# BHPC MEETING PACKET

A. COA 24-32

930 W 6th St (Near West Side HD)

Replacement of doors on gabled el and replacement of siding on gable porch

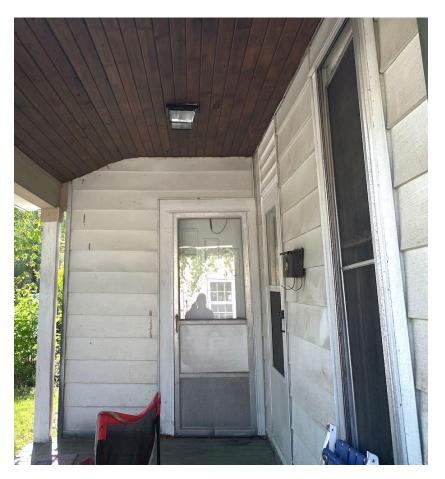
**Background:** Alterations were recently made to the front porch of this gabled-el cottage in the Near West Side Historic District without the receipt of a Certificate of Appropriateness including the removal of one of the front doors located on the porchfacing interior of the el and replacement of the horizontal vinyl siding with vertical hardie board.

**Request:** The petitioner is proposing to install two replacement doors with 2/2 glass panes covering the top two thirds of in the locations of the unoriginal existing door and the removed door on the el. The petitioner would also like to retain the vertical hardie board installed on the porch. Staff and the petitioner have discussed a 60 day compliance period.

Staff recommends approval of two proposed replacement doors and replacement of vertical fiber cement siding on porch with horizontal fiber cement siding.

Doors with large windows are not unusual on Contributing houses in the Near West Side Historic District, and the neighborhood design review committee does not object to the choice of doors. While the replacement of siding on the porch is a material improvement on the previous siding and the vertical

orientation is limited to the shaded porch area, the guidelines do recommend against vertically oriented siding.

"The renovation itself is in material conflict with the district's Design Guidelines, in at least two ways: The applicant removed the second entry door (one of the most characteristic features of houses in the neighborhood context), and covered the former entrance with vertical siding — a siding type called out specifically in the Guidelines as Not Recommended. We believe the vertical siding was installed to replace clapboard siding, which is the most appropriate siding type for the Near West Side."

The applicant now proposes to replace the original and second front door with matching new ones. He's provided a photo of the proposed replacement door, and while we feel that a door with a solid lower half and glass in the upper half would be more harmonious with the original doors in the neighborhood, we do not object to his choice of doors.

However, we also noted that the applicant also has covered the original clapboard siding with a vertically oriented paneling, which our Guidelines specifically call out as Not Recommended. The amended CoA application does not acknowledge this objection or propose to remedy the situation. Accordingly, we remain opposed to the granting of the CoA for 930 West 6th.
